UNITED STATES PATENT AND TRADEMARK OFFICE

APPLICATION NO.	FILING DATE	FIRST NAMED INVENTOR	ATTORNEY DOCKET NO.	CONFIRMATION NO.
10/554,451	12/12/2007	Robert G. Roodman	4456-053195	9061
28289 7590 10/01/2010 THE WEBB LAW FIRM, P.C. 700 KOPPERS BUILDING 436 SEVENTH AVENUE PITTSBURGH, PA 15219				
EXAMINER MENON, KRISHNAN S				
ART UNIT		PAPER NUMBER		
1797				
MAIL DATE		DELIVERY MODE		
10/01/2010		PAPER

DETAILED ACTION

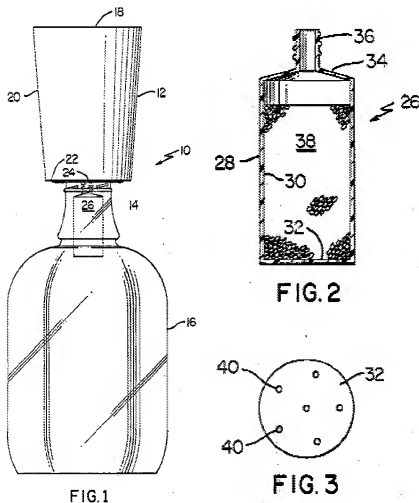
These claims recite a "pressure mechanism" and the "housing" which are unclear. Claim 2 recites that the pressure mechanism urges the wine from the source through the entry portion and the filtration device to the collection portion, which implies that the pressure mechanism includes a hand-pump or a gas cylinder/supply. Claim 3 recites a pump mechanism configured to inject gas, and is recited as a separate from the pressure mechanism. Claim 8 recites the neck engaging portion as part of the pressure mechanism. Claim 18 has the pressure mechanism and the filter device in a housing, and there is no mention of the pump mechanism. The housing is shown as an oval line fully or partially surrounding the parts 36 (a pump), 90 (battery), neck portion (44) and item 22 (filter). What are included in the 'pressure mechanism' and the 'housing' are therefore unclear.

The claim details and the disclosed figures do not make clear structural connections between the elements of the claims. The Examiner respectfully request further clarification.

For examination, the pressure mechanism is assumed as fluid passage having an entry and an exit

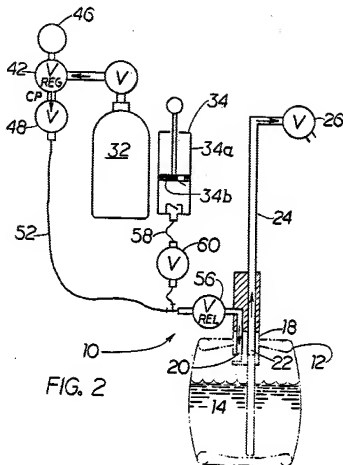
Claim 2: Sway teaches a the internal passage way connecting wine entry with wine exit through a filter as claimed – see the figure of Sway. However, Sway does not teach the pressure mechanism as claimed. Lowers teaches a pressure mechanism for dispensing fluids from a container - see the figure copied herein with all the structural details. It would have been obvious to one of ordinary skill in the art at the time of invention to have such a pressure mechanism as taught by Lowers in the teaching of Sway for the convenience of transferring or dispensing the liquid from the container and through the filter device of Sway. Such dispensing devices are also well known in the art (see for further evidence Shannon (US 4,624,391) which teaches a wine dispenser and Carr (US 4,454,967) – Fig 1: a common drum pump.

Claim 3 recites a gas entry and pump mechanism to the pressure mechanism of claim 2. Lowers teaches both a hand pump (34) and a gas pump (32) mechanism for the dispenser. Claim 8 has a container with a neck portion – see container (14) has a neck portion (18), and a neck engaging portion – (19 and 19a – fig 1.)

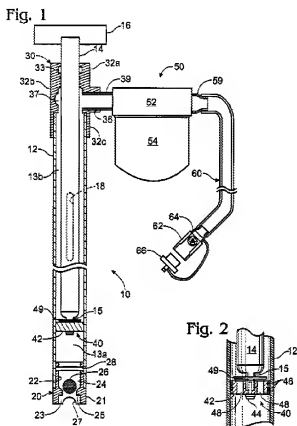
Walker teaches a filter apparatus as shown in fig 1 copied herein. The filter mechanism has a pressure mechanism including the pump and the conduits, filter (54) attached to the pump and a filtered fluid exit tube (60). Regarding the wine source with container and neck portion, the Walker device is meant for containers such as bottles and the pump (10) is capable of engaging with bottle necks.

The reference does not explicitly show a wine source and a filtered fluid container, but such would be obvious to one of ordinary skill in the art.
